22462 I-70 Bethune Pavement Reconstruction Project Final Value Engineering Report

COLORADO
Department of Transportation

Date: January 2020

VE PROPOSAL VE-1	
PROJECT: 22462 I-70 Bethune East and West Pavement Reconstruction Project	Idea No.: 4 Date: July 23 rd , 2019
DESCRIPTION OF VE PROPOSAL: Eliminate edge drains	Page No.: 2 of 3

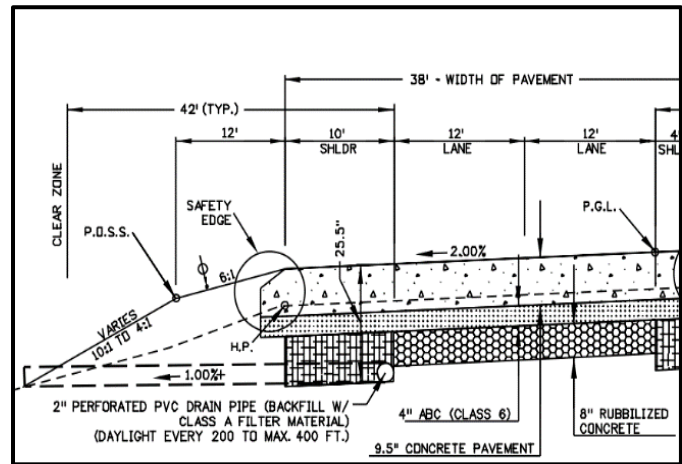
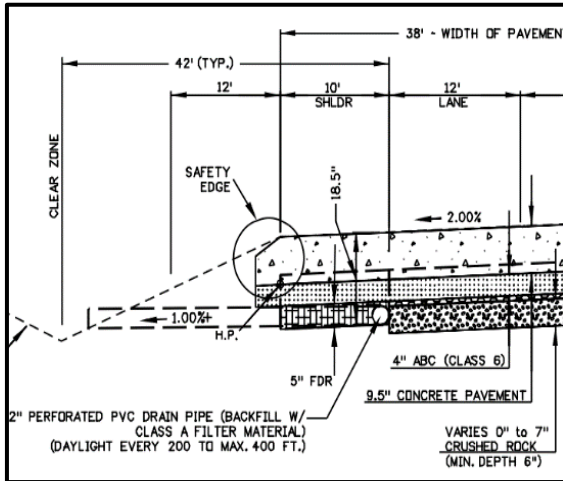
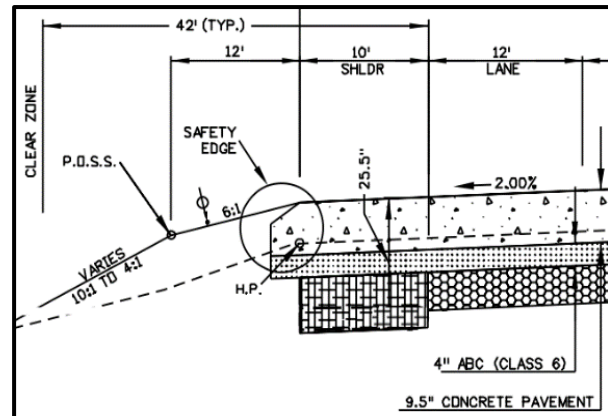
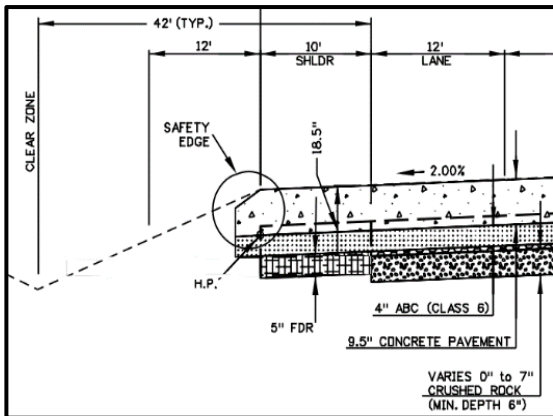
The original design shows an edge drain under the right shoulder adjacent to either rubblized concrete or crushed rock for approximately 100,962 LF. The drain is shown to be daylighted every 200', with a max of 400'. The intent of the drain is to remove water from the roadway prism.

It was assumed that the entire quantity for "Pipe Edge Drain" is removed from the project. Material to fill the void was already accounted for in the original design estimate.

VE PROPOSAL VE-2	
PROJECT: 22462 I-70 Bethune East and West Pavement Reconstruction Project	Idea No.: 5 Date: July 23 rd , 2019
DESCRIPTION OF VE PROPOSAL: Optimize the typical sections	Page No.: 3 of 5

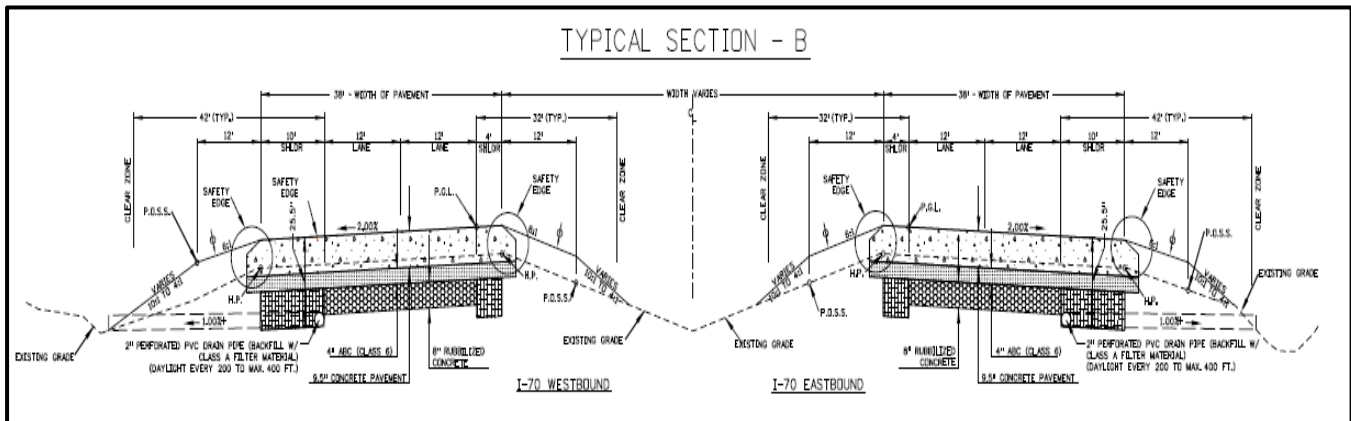
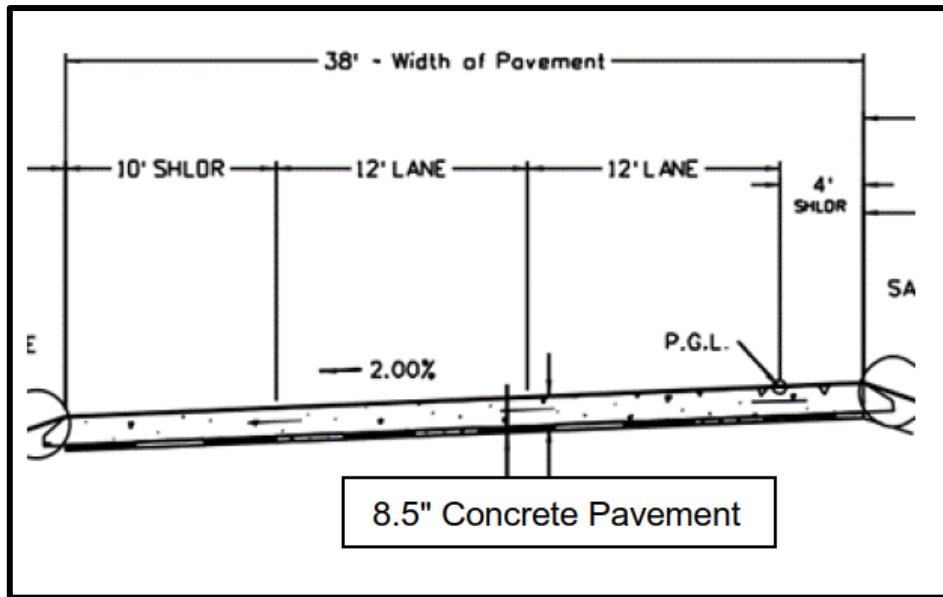
The current design shows Class-P PCCP being installed, per specifications. The original design includes milling off all the existing HMA, full depth reclamation of the shoulders, rubbilize the existing PCCP, add edge drains along the shoulder with outlet structures, add 4 inches of aggregate base course, and place 9.5 inches of PCCP on the mainline of Interstate 70.

The proposed PVC design has the potential to increase the amount of transverse cracking thus reducing service life compared to the base case design. However, the proposed design meets the 27-year distress threshold as per CDOT 2020 Pavement Design Manual. It would also require time and costs to redesign what is currently shown in the plans.

VE PROPOSAL VE-4	
PROJECT: 22462 I-70 Bethune East and West Pavement Reconstruction Project	Idea No.: 9 Date: July 16 th , 2019
DESCRIPTION OF VE PROPOSAL: Offset the ramp alignments for Bethune	Page No.: 3 of 4

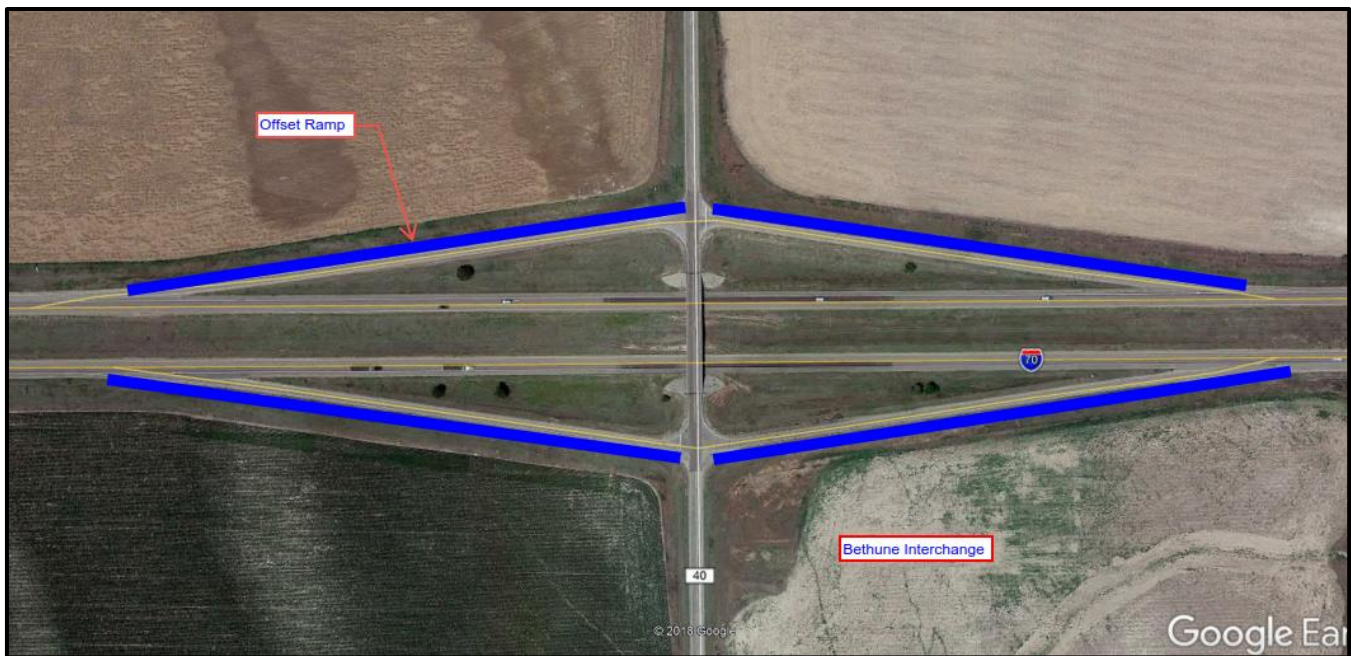
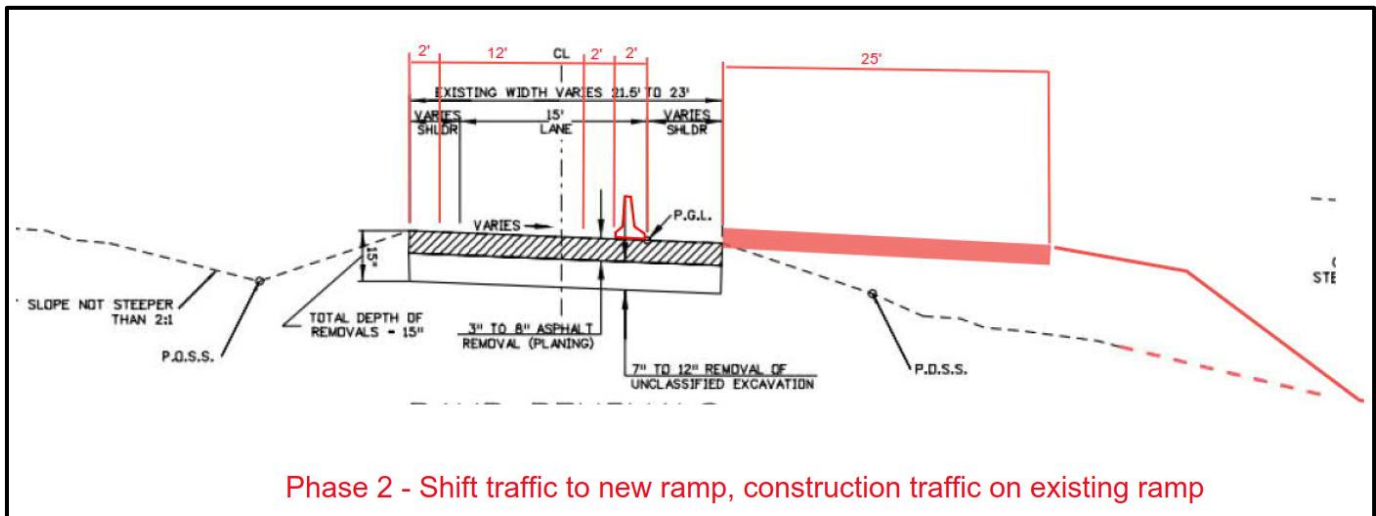
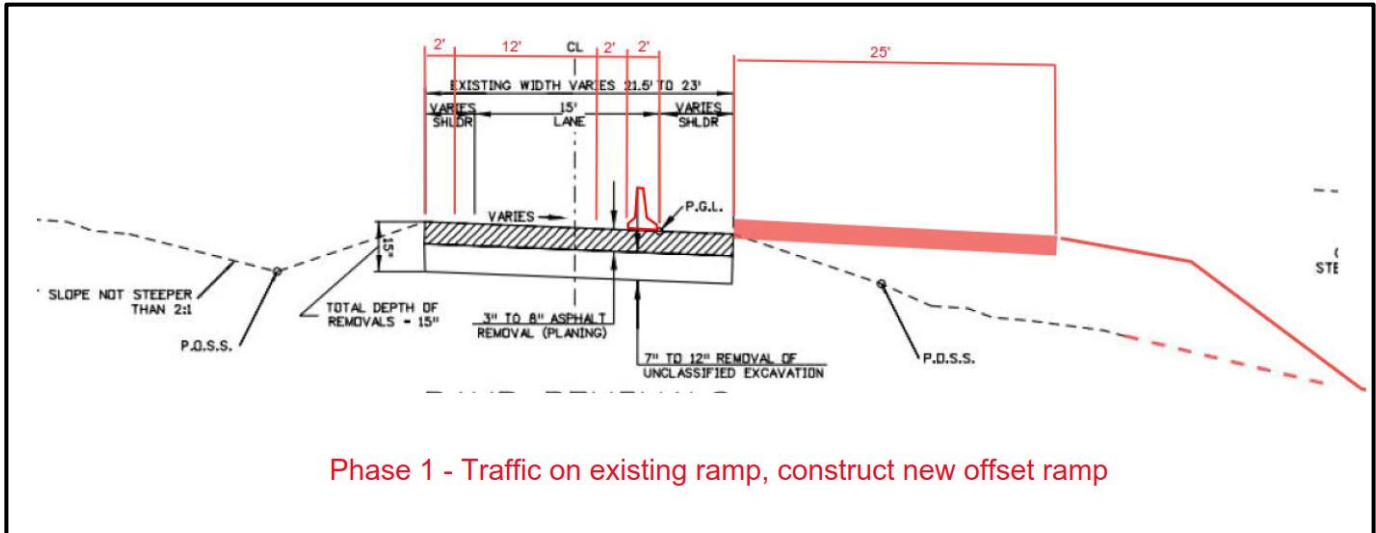
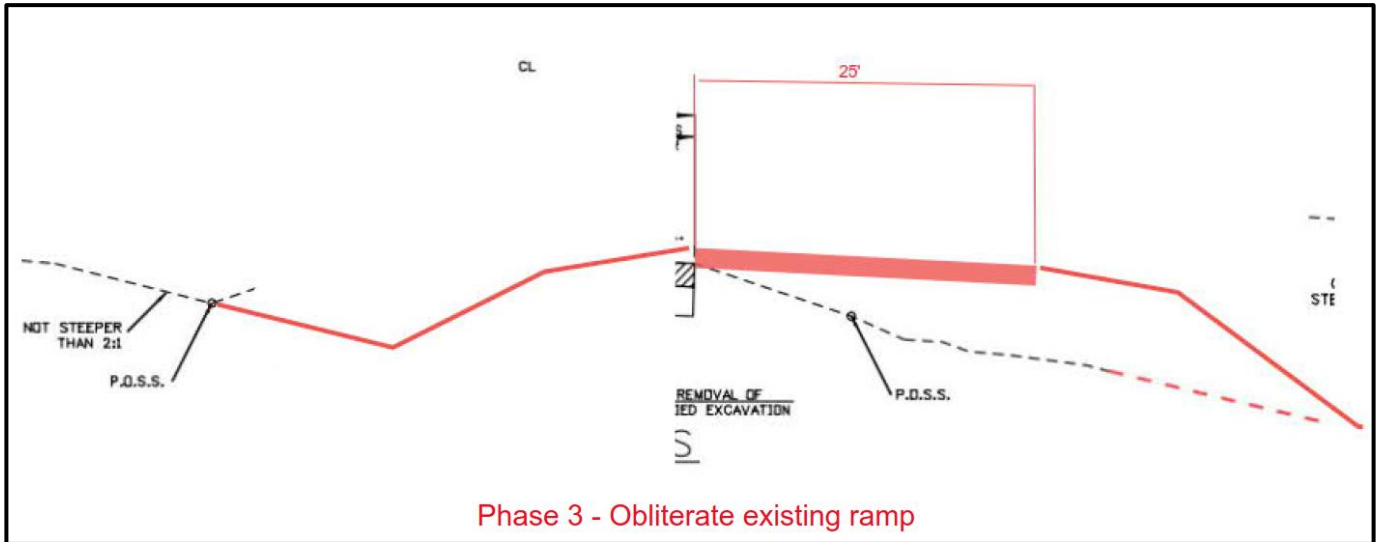
Ramps at the Bethune interchange are currently planned to be reconstructed in their present location (i.e. no changes in alignment or profile). Pavement structure will be 9” of PCCP over 6” of ABC. To construct the ramps, it will be necessary to either close the ramps temporarily and detour traffic, or to construct the ramps one half at a time. The ramps will be used by both general traffic and construction traffic during construction which introduces the potential for accidents and conflicts.

Unit costs are based upon Project Code #22462 I-70 Bethune FIR cost estimate and Project Code #21878 Arriba Bid tabs. Assume pavement costs for offset alignment will be the same as for the base case design. Added a 25% contingency to cover minor items blading, seeding, etc. Some items including signing, striping, delineators, etc. will be the same under the base case alternative. Costs for proposed idea do not include any credits back for traffic control.

VE PROPOSAL VE-11	
PROJECT: 22462 I-70 Bethune East and West Pavement Reconstruction Project	Idea No.: 39 Date: July 23 rd , 2019
DESCRIPTION OF VE PROPOSAL: Optimize the PCCP thickness and reduce the amount of concrete needed by milling the existing HMA to adjust the cross slope	Page No.: 3 of 6

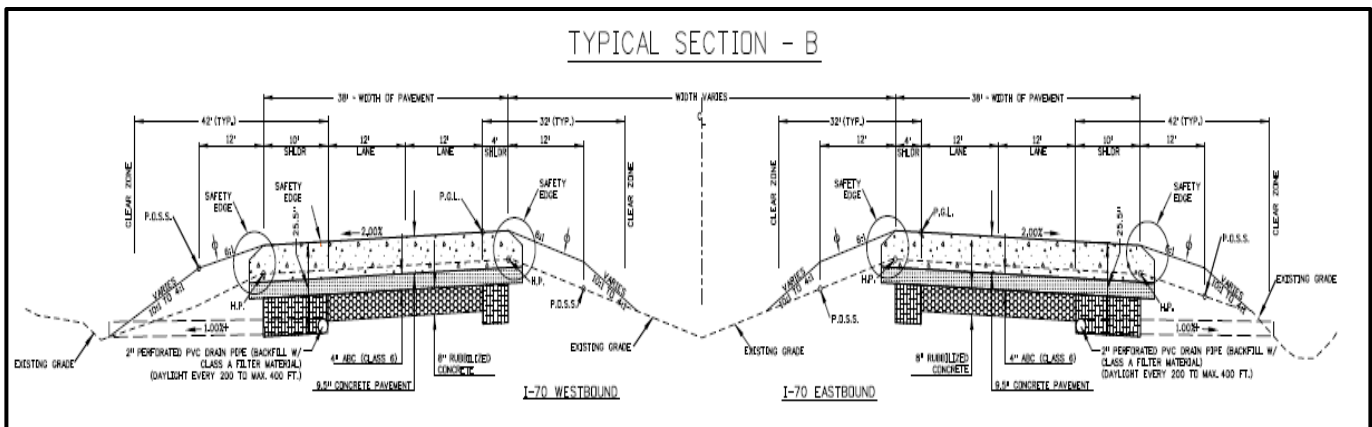
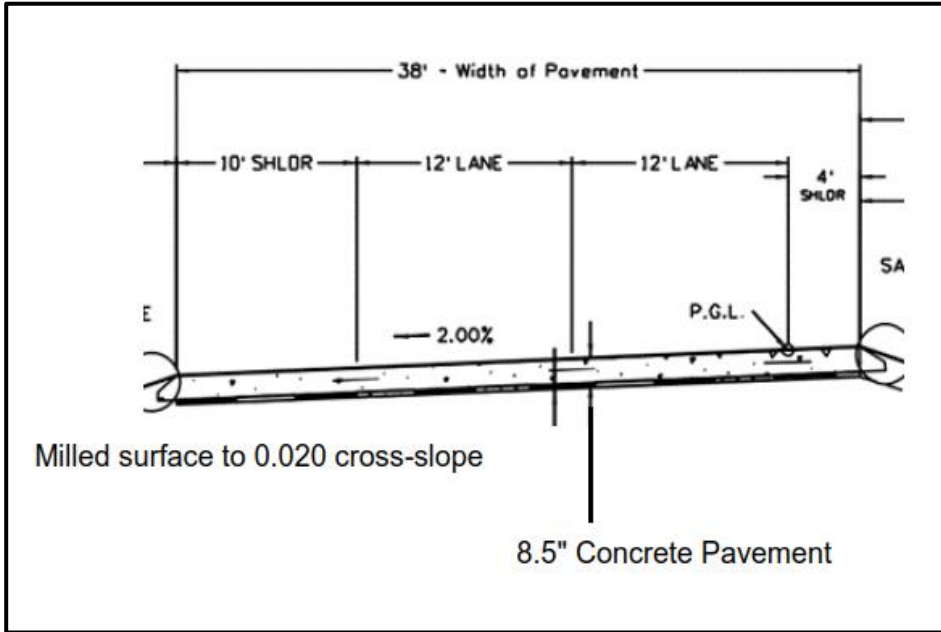
Based on the current thickness of the HMA, milling the cross-slope will not impact the minimum HMA thickness needed to support the PCCP. The 2018 CDOT Pavement Management Data indicated that the maximum rut depth was 1.94 inches. Milling the cross-slope will remove approximately 1.1 inches from the left wheel path and approximately 1.6 inches from the right wheel path. Since 2018, maintenance forces have placed numerous thin-lift overlays to address the ruts in HMA. The Contractor would need to fill any remaining ruts with PCCP.

It would require time to redesign what is currently shown in the plans.

PROJECT: 22462 I-70 Bethune East and West Pavement Reconstruction Project	Idea No.: 10 Date: July 16 th , 2019
DESCRIPTION OF DESIGN COMMENT: Use State Highway 24 as a temporary detour for ramp closures	Page No.: 2 of 3

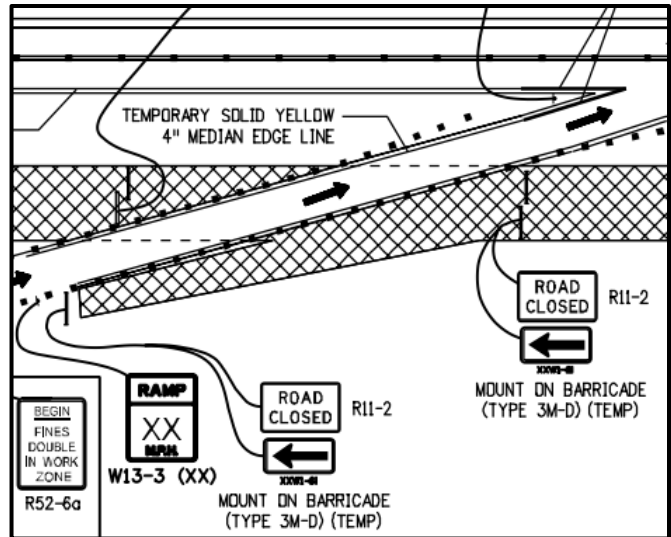
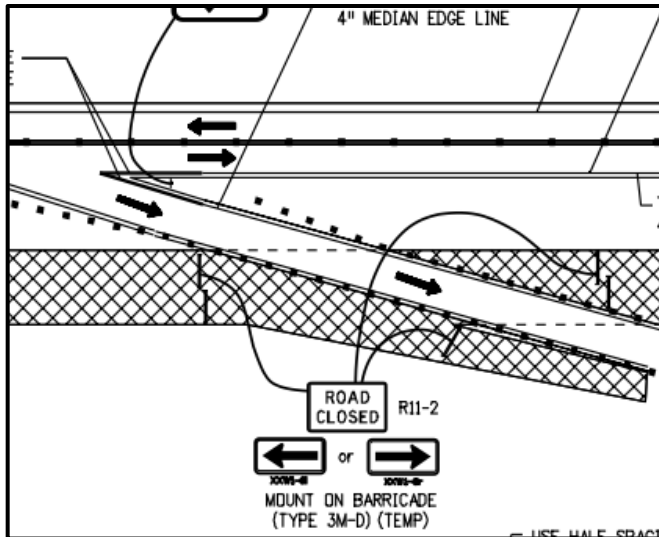
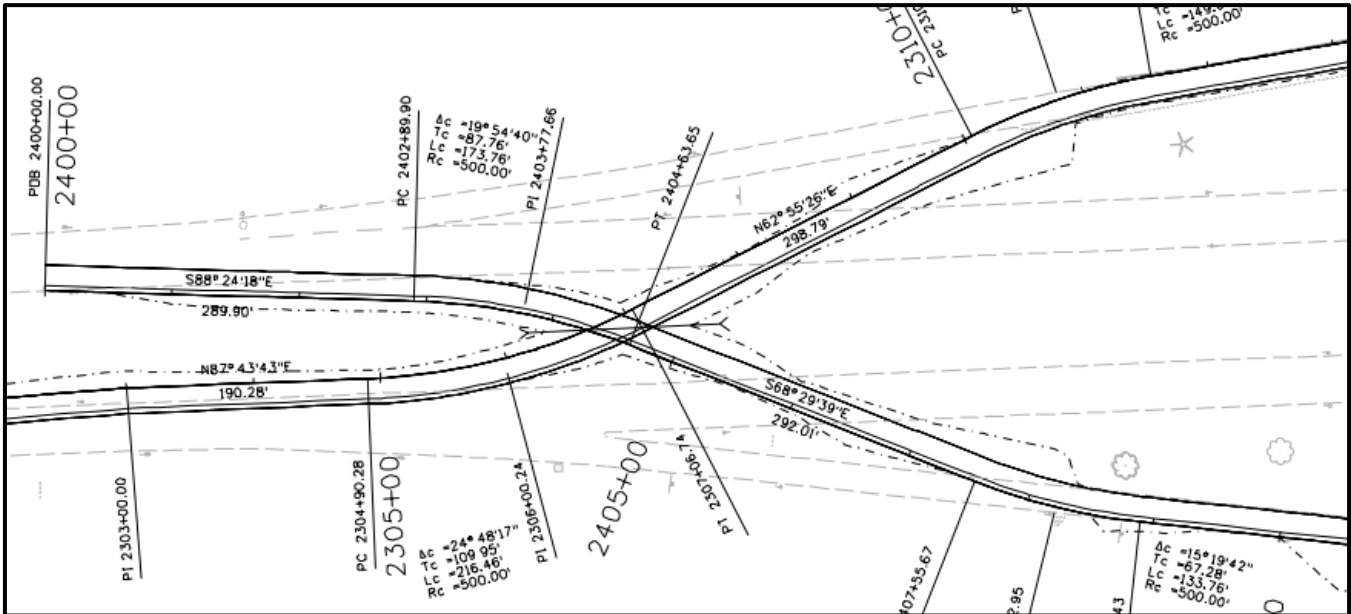
This would allow the Contractor to construct each ramp full width without the need to maintain and shift traffic. This should provide improved quality of the pavement construction, protect workers within the construction zone and reduce the potential for vehicle conflicts with construction traffic. It would also eliminate the need for the 2nd temporary ramp crossover to pave the mainline in its entirety, thus saving on detour pavement costs.

PROJECT: 22462 I-70 Bethune East and West Pavement Reconstruction Project	Idea No.: 18 Date: July 16 th , 2019
DESCRIPTION OF DESIGN COMMENT: Allow a temporary on and off ramp for construction vehicles close to center of project	Page No.: 2 of 2

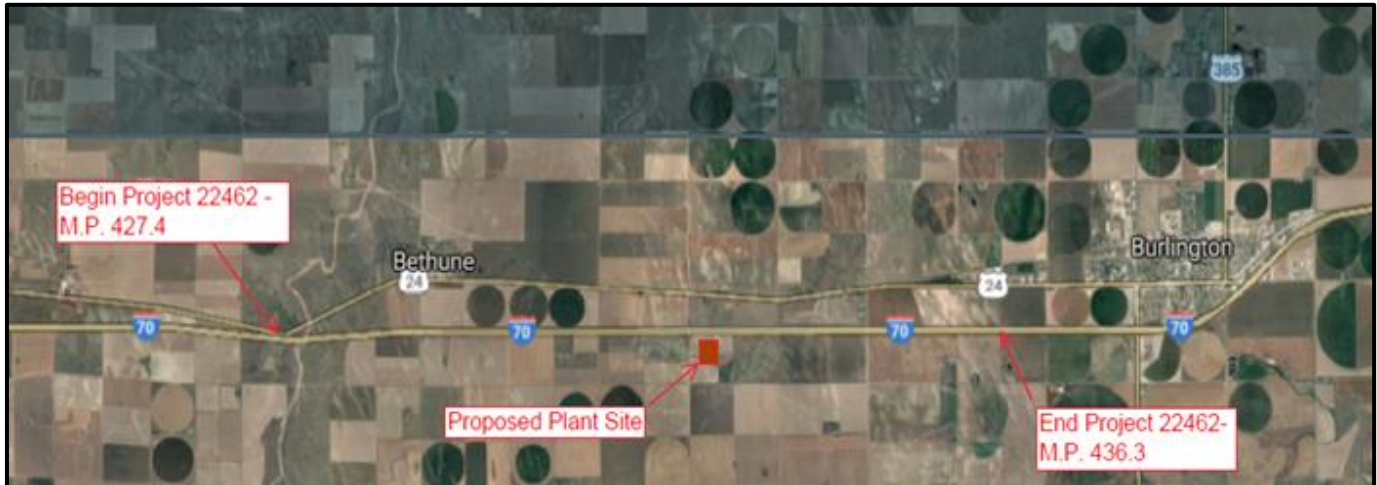
This project currently has no phasing plans to incorporate as to where the Contractor can place their concrete plant. It is up to the Contractor to find a land owner who will lease property to the Contractor to set up their plant.

DESIGN COMMENT DC-6

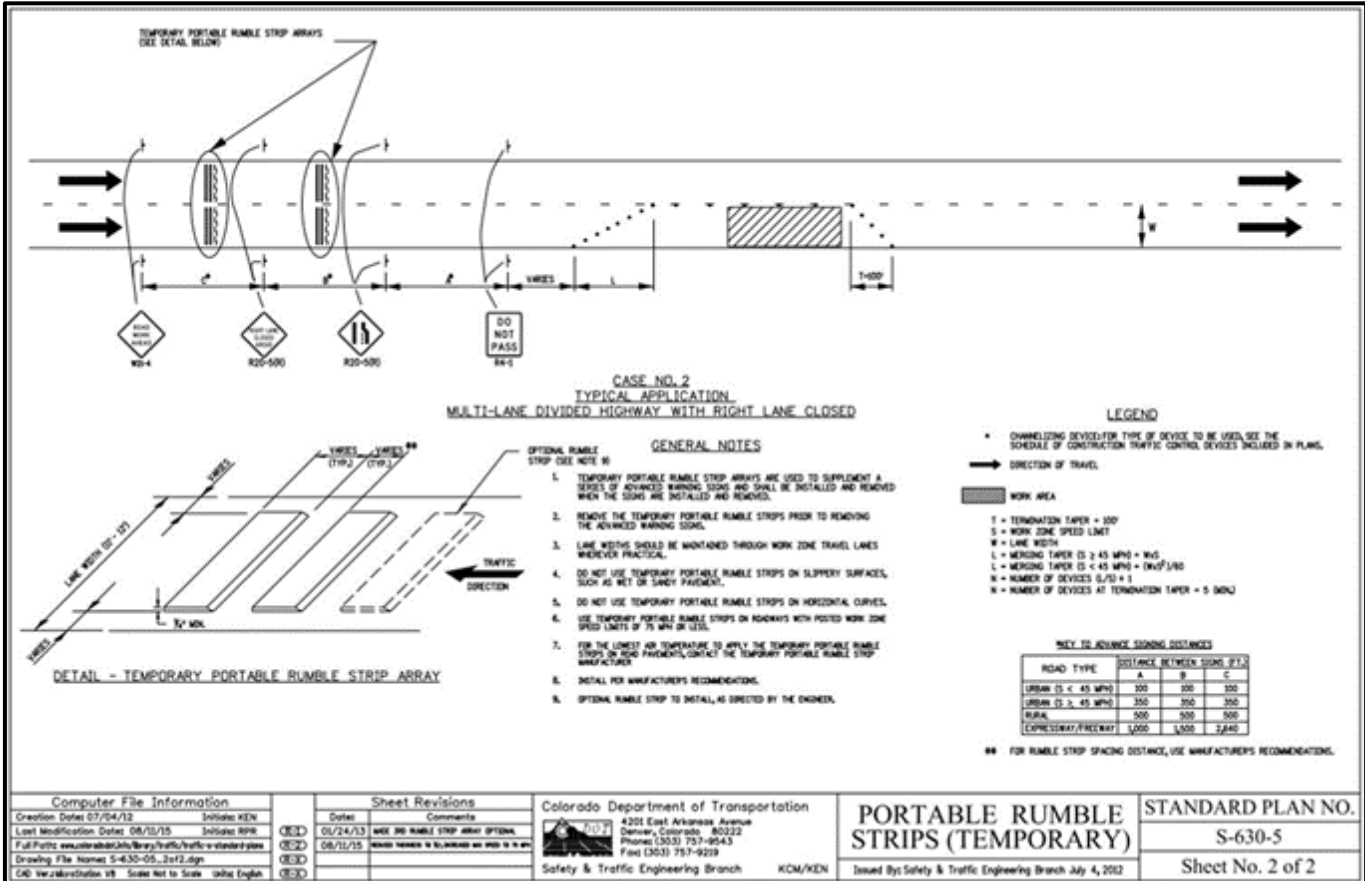
It was suggested that the item for portable rumble strips may be added to the project to enhance the traveling public awareness of entering a work zone.

By adding the item Portable Rumble Strips, it may cause impacts to the traveling public if maintenance of this item needs to be addressed.
